**ALBERTA TRANSPORTATION
SPRINGBANK OFF-STREAM RESERVOIR
PROJECT
Response to NRCB and AEP
Supplemental Information Request 2,
dated November 18, 2019**

Prepared for:
Alberta Transportation

Prepared by:
Stantec Consulting Ltd.

April 2020

Figure 9-5. POI Hydrographs near Northeastern Edge of Reservoir

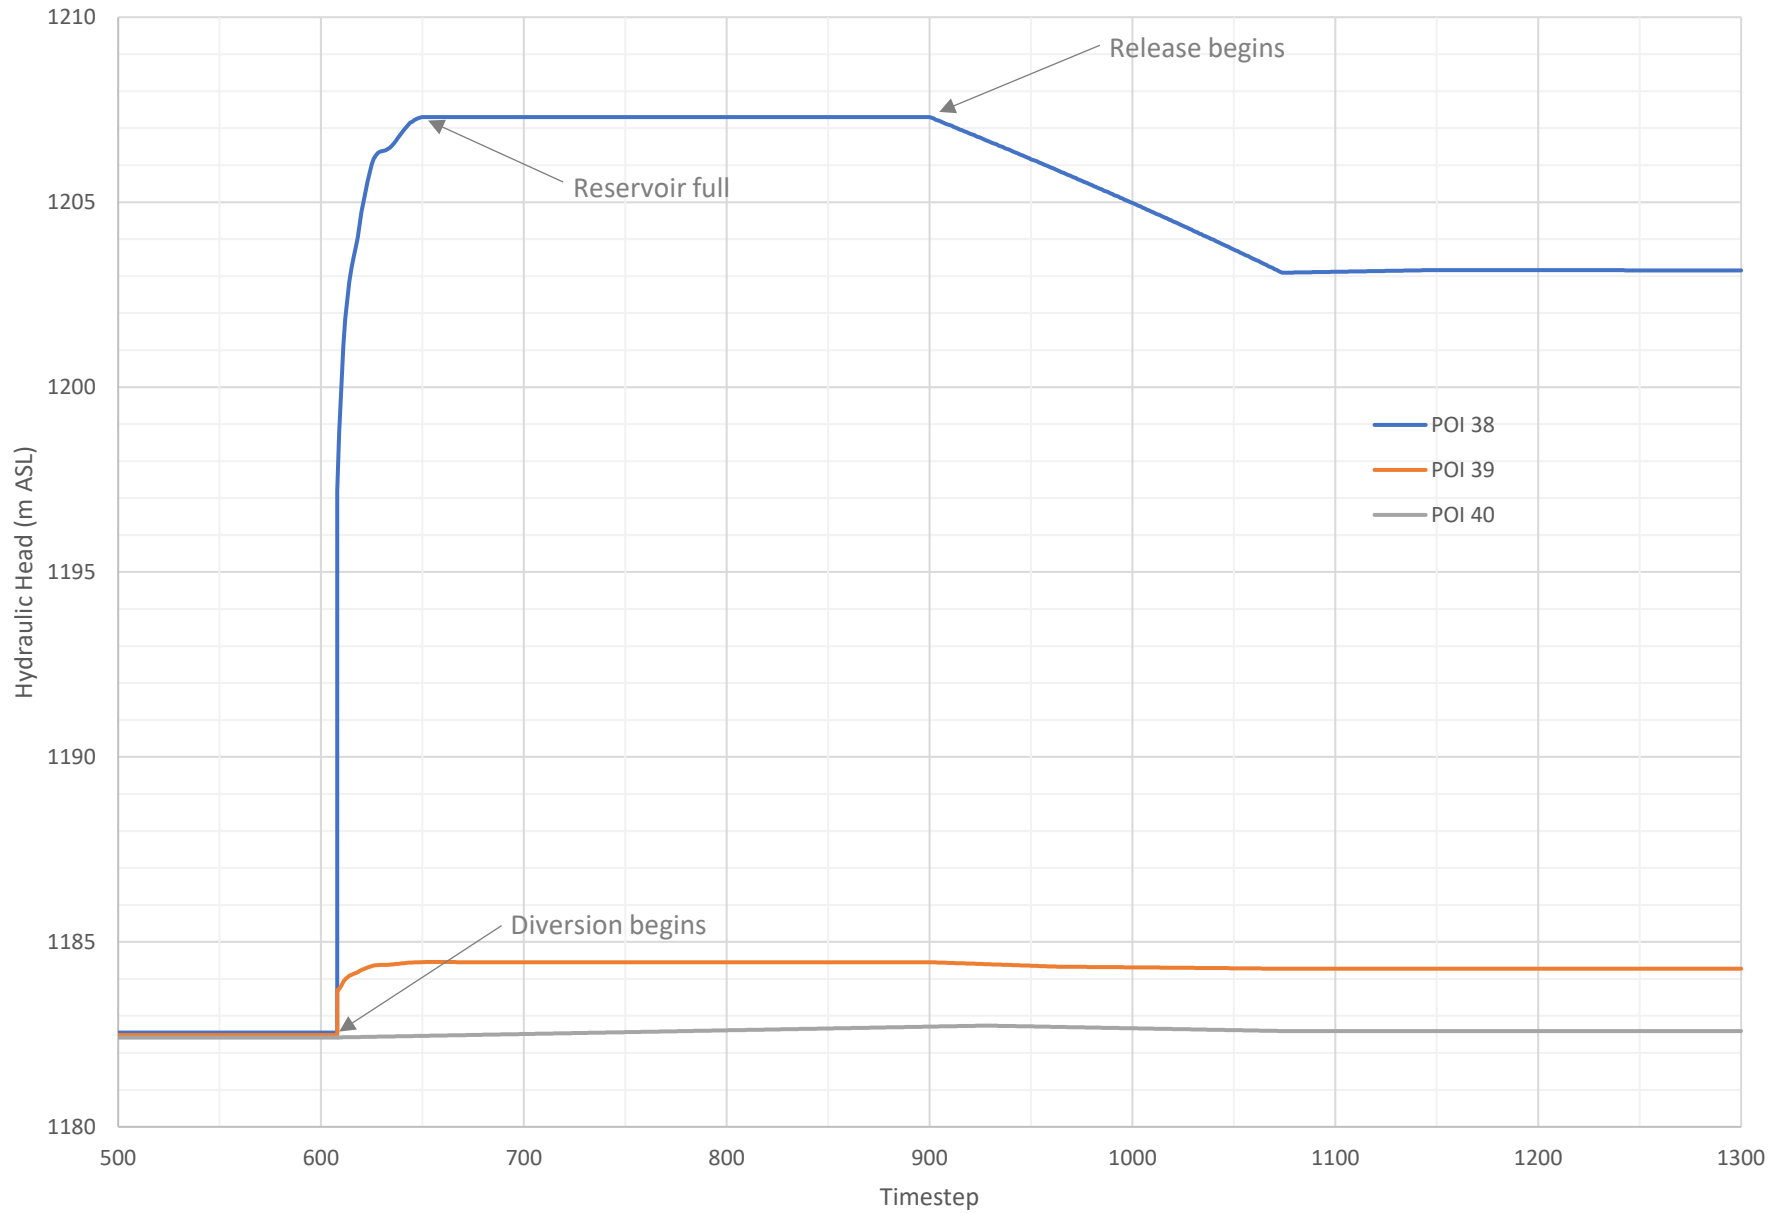
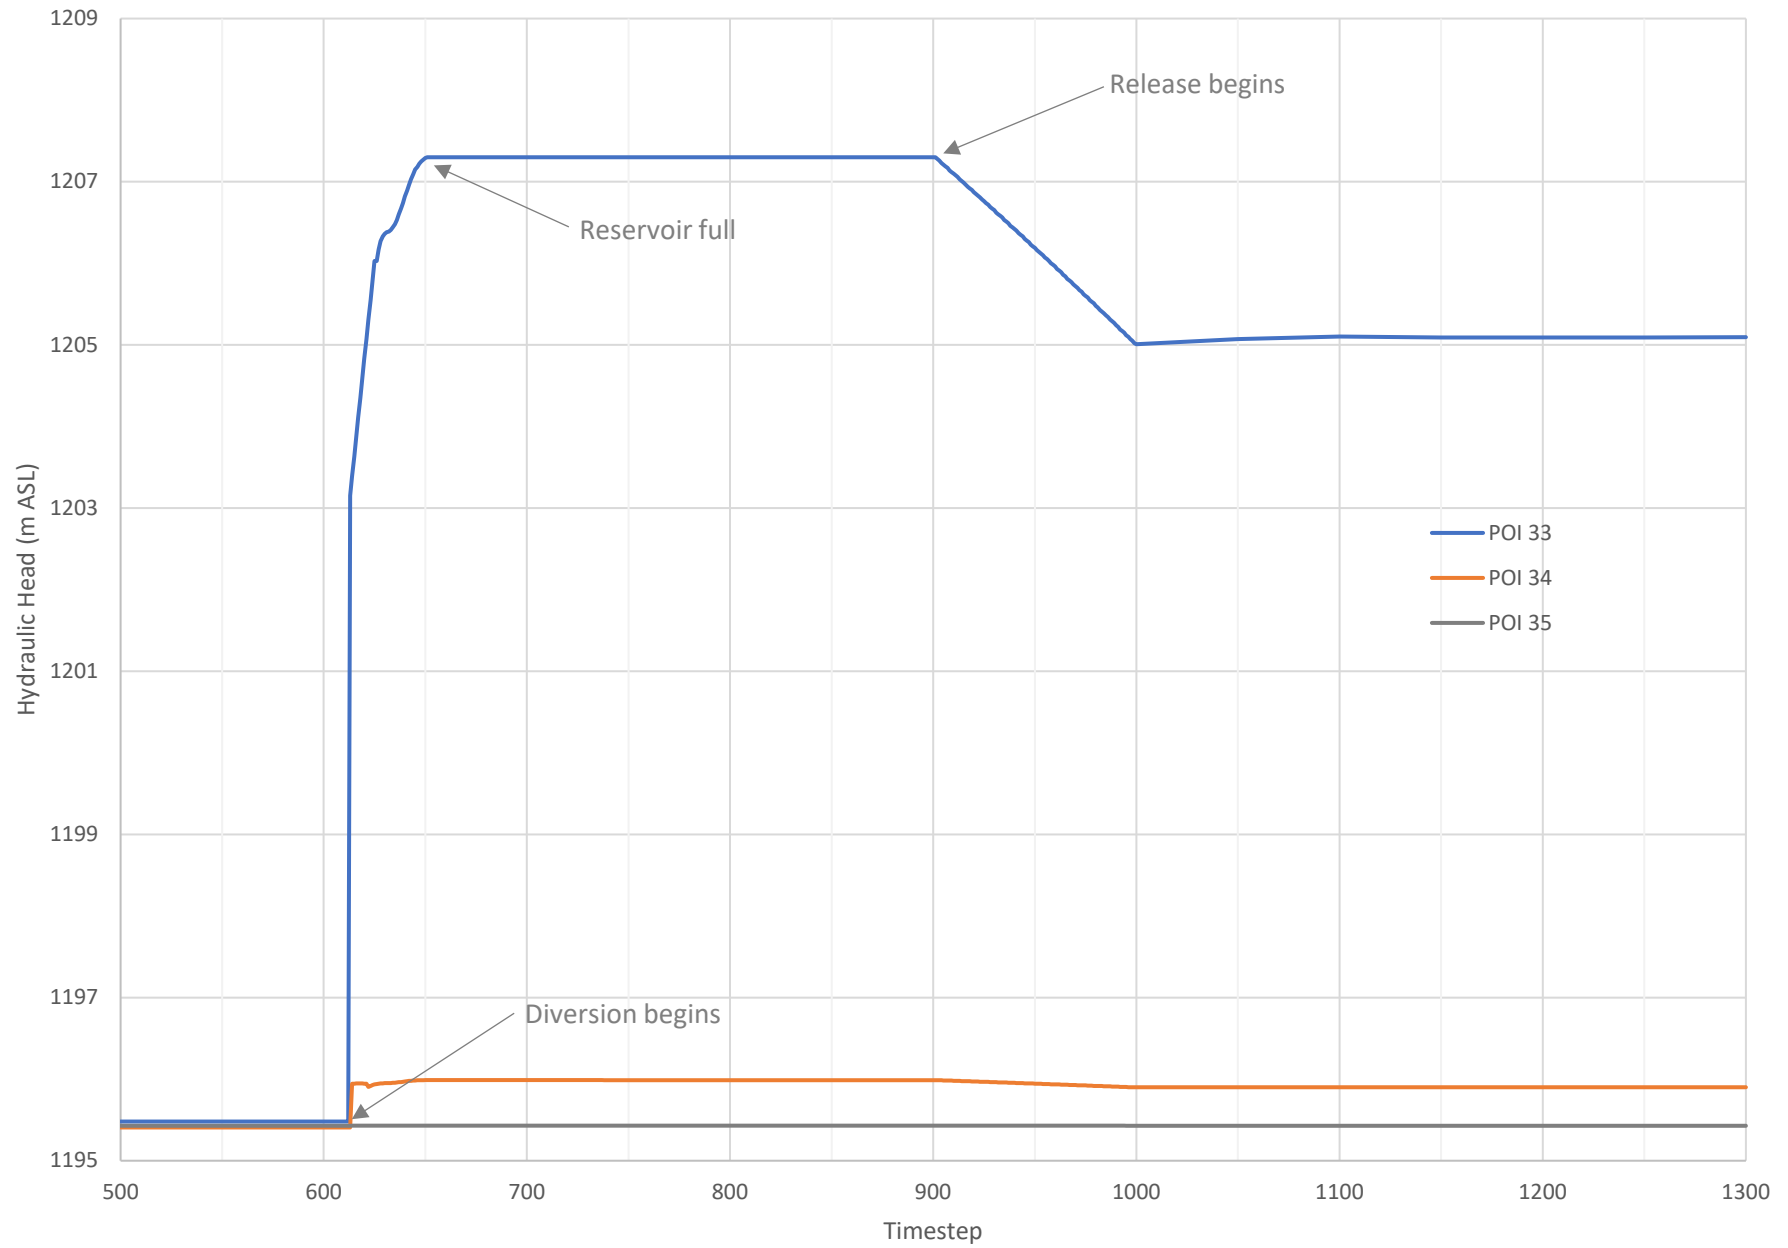
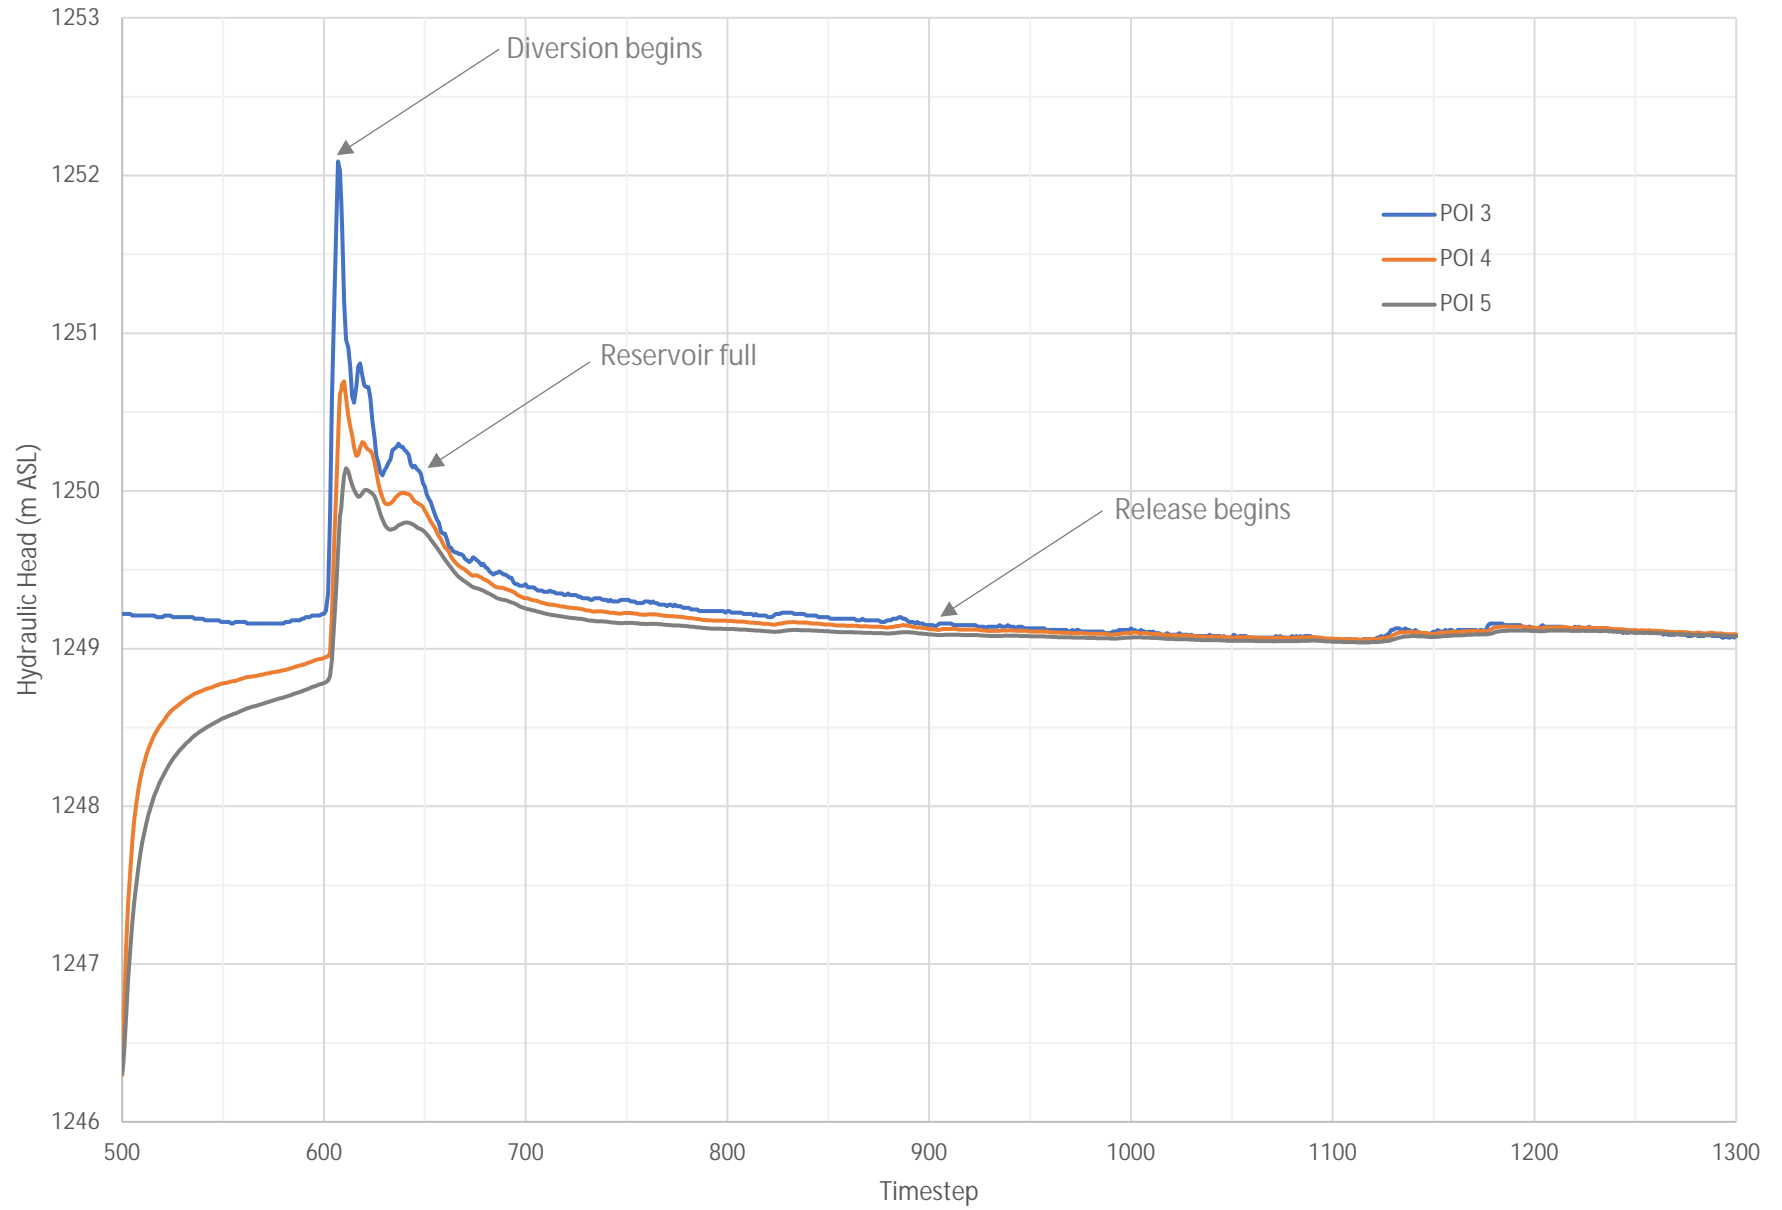
No time series plots are provided for the Points of Interest in Appendix IR42-1, Figure 5-4.

a. Provide the plots requested in Question 258.

a. Figure 9-1 presents the locations of the points of interest (POI). The following discussion presents time series hydrographs for POI in areas near the diversion channel and reservoir. All timesteps referenced in Figure 9-2 to Figure 9-6 are one-hour increments of elapsed time since the start of the simulation for the design flood.

Figure 9-2 presents hydrographs for three POI (24, 25 and 26) near the north side of the diversion channel. Point 26 shows the response to water levels in the channel resulting from the diversion of water from Elbow River. Point 25 is located approximately 10 m north of Point 26 and shows a delayed and dampened response, increasing approximately 4 cm beginning at timestep 605, followed by a gradual increase of 6 cm by timestep 1,300 (the end of the simulation). Point 24, located approximately 20 m from the channel, shows further dampening with effectively no response immediately after the diversion begins, followed by a lagged 8 cm increase by timestep 1,300.

Figure 9-3 presents hydrographs for POI on the south side of the diversion channel. The results are similar to observations for the north side of the diversion channel, although a more immediate and higher magnitude response is observed at the nearest point (Point 27) to the channel. Point 27 on the south edge of the channel shows the water level response due to the diversion of water within the channel. Point 28 is located approximately 10 m from the channel and shows a dampened response, increasing a maximum of 60 cm between timestep 605 and 616, but decreasing over the remainder of the simulation. At Point 29, located approximately 20 m from the channel, no response to the diversion of water is observed.

Figure 9-4 presents hydrographs for POI on the southeastern edge of the off-stream reservoir. Point 38 shows the response to the reservoir water reaching a maximum level of 1,207.3 m asl during the design flood, and following release of the water, remaining near the ground surface after the design flood has passed (to simulate continued near surface saturation). At Point 39, located approximately 10 m from the reservoir, an increase in hydraulic head of 2.1 m is followed by a gradual decrease (once water is released after the design flood) over the remainder of the simulation. Further dampening of effects on water levels is observed away from the reservoir, with only approximately 0.30 m of change at Point 40, located

Figure 9-5 presents hydrographs for POI on the northeastern edge of the reservoir. Point 33 shows the response to retention of water when the reservoir water reaches a maximum level of 1,207.3 m asl (during the design flood) and remaining near the ground surface after the design flood has passed. At Point 34, located approximately 35 m from the reservoir, a maximum increase in hydraulic head of 0.56 m is followed by decreasing levels after the design flood has passed for the remainder of the simulation. Further dampening is observed away from the reservoir, with essentially no change in water levels noted during the design flood at Point 35, located approximately 90 m from the reservoir.

Figure 9-6 presents hydrographs for POI near Elbow River south of the LAA. Hydraulic head changes are observed in the alluvium as a result of changes in river stage during the design flood. Point 3, adjacent to the river, shows the response to the specified head over the transient flooding simulation. Point 4 and Point 5 show an initial increase between timestep 500 to 600 when the simulation is adjusting from the steady state hydraulic head values to the transient head values specified for the river. Following the initial increase, the dampening effect is observed in the sand and gravel aquifer at distances of 30 m and 60 m from the river, respectively.

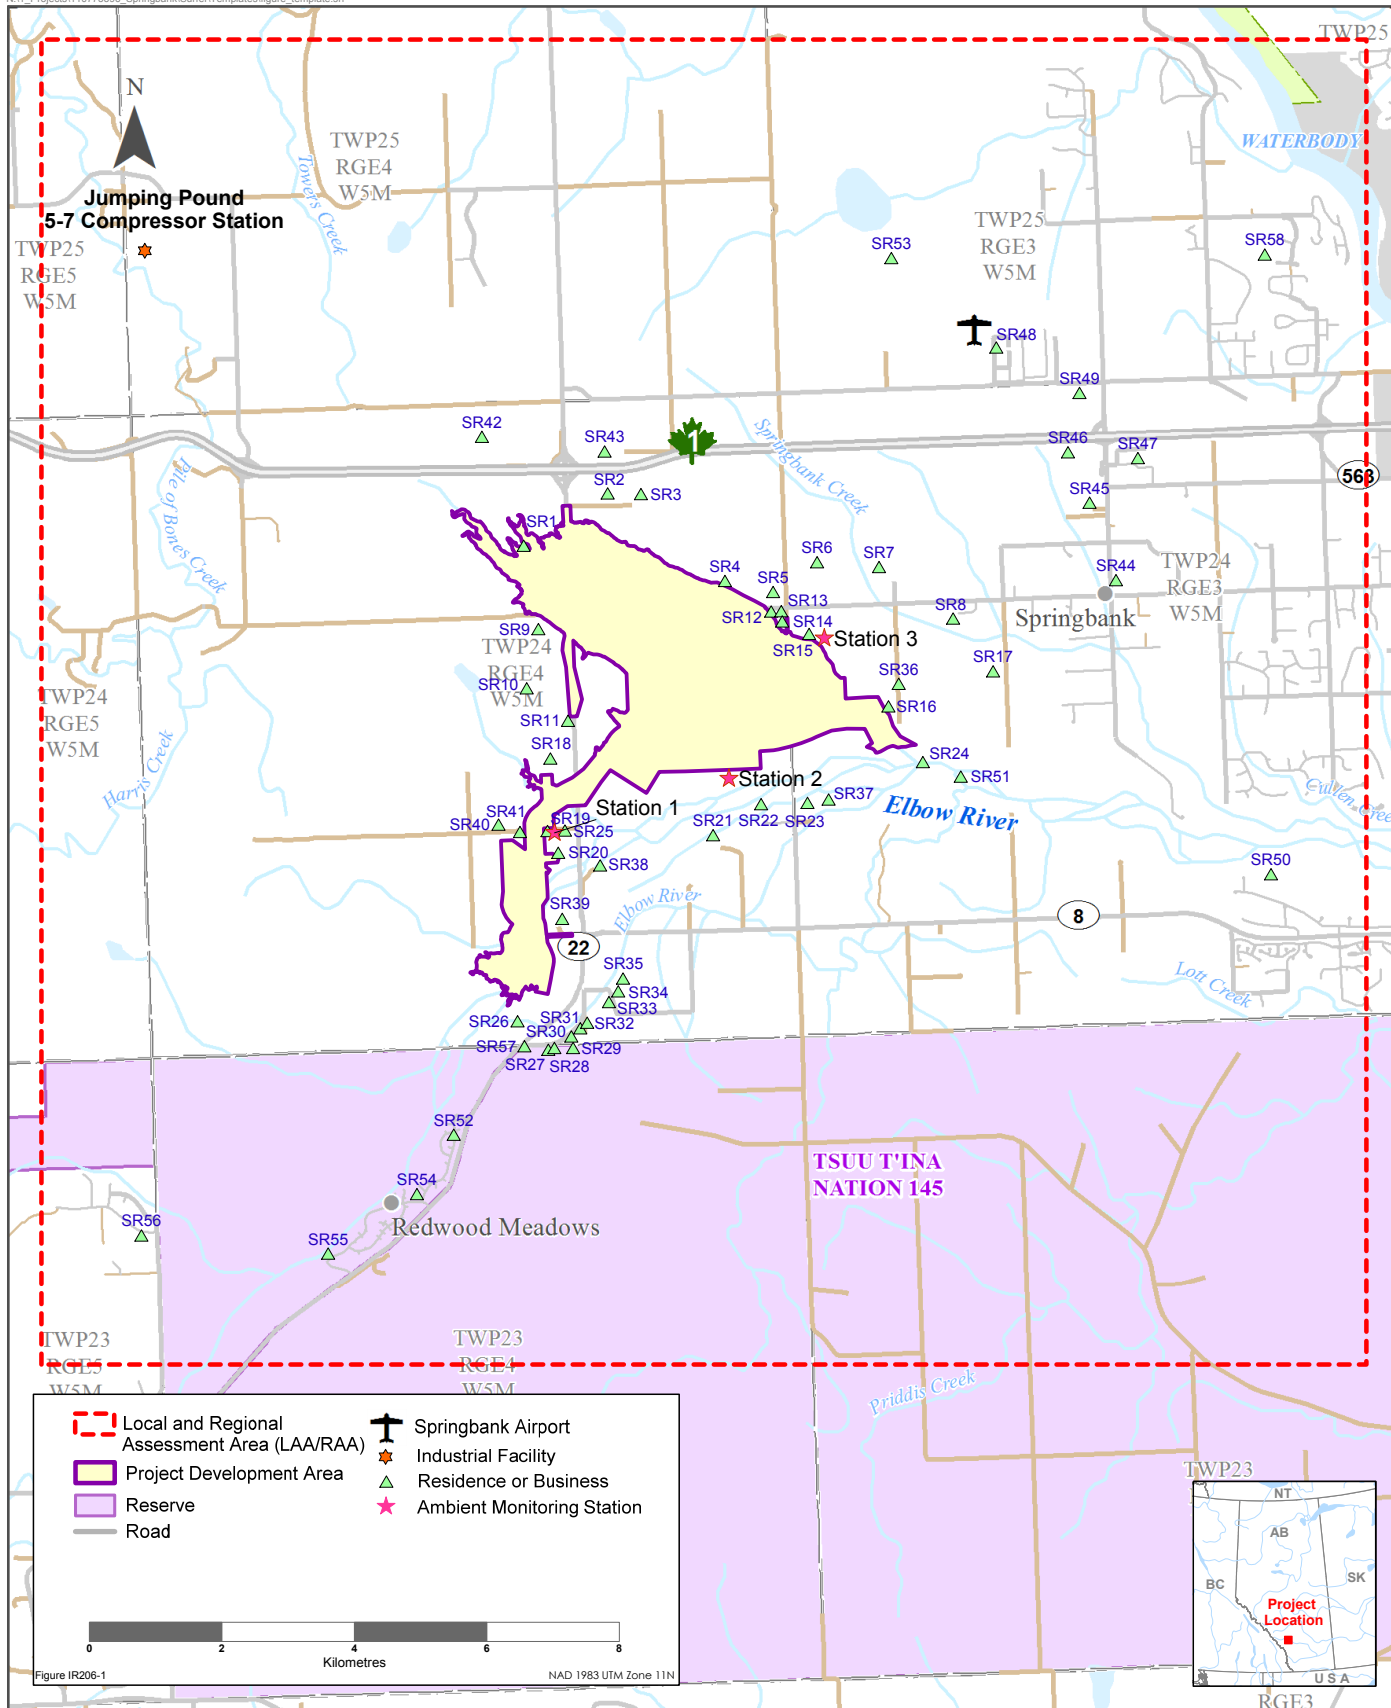
Alberta Transport states *During construction, activities between the diversion channel and the dam, there will be 24-hour continuous wind and air quality monitoring for PM_{2.5} and TSP at Stations 1 and 2 along the haul road and at Station 3 near the borrow source area as illustrated on Figure IR206-1. The proposed locations of the air quality monitoring stations were selected based on modelling results.*

a. The proposed monitoring program has been adjusted to provide monitoring data representative of the SR41 and SR19 locations. The proposed monitoring program is explained in detail below.

Three ambient air quality monitoring stations are proposed outside the PDA, as described in Alberta Transportation's response to Round 1 AEP IR206 and shown in Figure IR206-1. The ambient air monitoring will include monitoring of PM_{2.5} and TSP. The locations of the air quality monitoring stations are based on the highest expected fugitive dust emissions generated by the haul trucks transporting earth material from the diversion channel to the dam, and the spatial distribution of maximum predicted PM_{2.5} and TSP concentrations.

Two monitoring locations (Station 1 and Station 2) are proposed between the haul road from the diversion channel excavation work to the dam construction site and nearby residences, and one monitoring location (Station 3) is proposed between the borrow source area and nearby residences (see Alberta Transportation's response to Round 1 AEP IR206, Figure IR206-1).
